Simplifications and enhancements for P802.1ASdm D1.1 around ptpInstanceState

Author: Johannes Specht

Date: 31.07.2023

- 10. Delete 17.5.3.3.
- 11. Replace Figure 17-2 as shown.

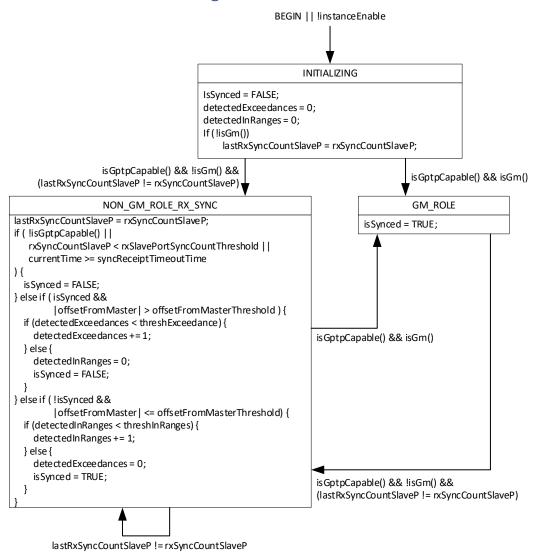
```
if (isGm()) {
 isSynced = TRUE;
} else {
  lastRxSyncCountSlaveP = rxSyncCountSlaveP;
  if ( !isGptpCapable() ||
     rxSyncCountSlaveP < rxSlavePortSyncCountThreshold ||
     currentTime >= syncReceiptTimeoutTime
    isSynced = FALSE;
  } else if (isSynced &&
          |offsetFromMaster| > offsetFromMasterThreshold) {
    if (detectedExceedances < threshExceedance) {
      detectedExceedances += 1;
    } else {
      detectedInRanges = 0;
      isSynced = FALSE;
  } else if (!isSynced &&
          |offsetFromMaster| <= offsetFromMasterThreshold) {
    if (detectedInRanges < threshInRanges) {
      detectedInRanges += 1;
    } else {
      detectedExceedances = 0;
      isSynced = TRUE;
    }
 }
```

lastRxSyncCountSlaveP != rxSyncCountSlaveP

- offsetFromMaster is a signed integer. Therefore, |offsetFromMaster| is used instead of offsetFromMaster.
- The code is equivalent with that from D1.1 of P802.1ASdm. However, the intended function may be different than both, that in D1.1 of P802.1ASdm and likewise that in the diagram, because the in-range/out-range counting logic may be intended to scan for consecutive syncs in sequence, rather than over the entire phase while the PTP instance is considered to be "sufficiently" or "insufficiently" synced (e.g., right now, 5 "bad" syncs with threshExceedance=5 would lead to a transition from "sufficiently" to "insufficiently" synched, irrespectively if the 5 "bad" syncs appear in a sequence of 10 or 10000000 syncs).

An alternative for discussion could be a window with the most recent M sync events for which either "good" (|offsetFromMaster| <= offsetFromMasterThreshold) or "bad"

(|offsetFromMaster| > offsetFromMasterThreshold) is stored, and of which at least N entries must be "good" with N \leq M and with configurable N and M.

In any case, the author's hope is that a compact form eases reviewing and commenting.
